## **NFPA Technical Meeting (Tech Session)**

### **AGENDA**

**NFPA Standards presented for Action – Wednesday, June 7, 2017**

A.4.4.1.1 NOAA (National Weather Service) Temperature Humidity Index Chart

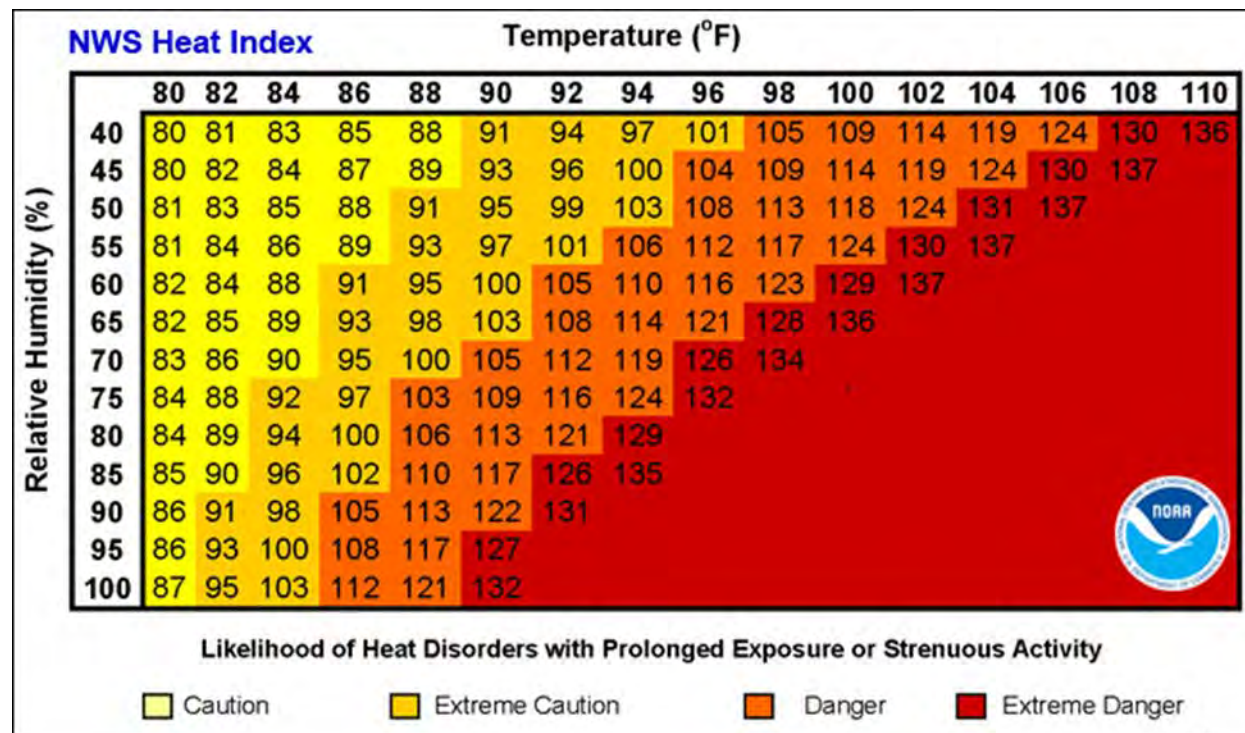
**Motion Seq#**      **Certified Amending Motion:** Accept Public Comment No. 7

4.4.1 Participants engaged in strenuous physical activity during live fire training shall be limited to a maximum of four (4) sessions, or evolutions, of a duration of a maximum of 20 minutes each, in a high-temperature environment per day. ~~Instructors and participants shall be rehabbed in accordance with the provisions of NFPA 1584, Chapter 6.~~

4.4.1.1\* A high-temperature environment shall be considered to be weather conditions that result in a Temperature Humidity Index (THI or Heat Index) of more than 90°F (32°C).
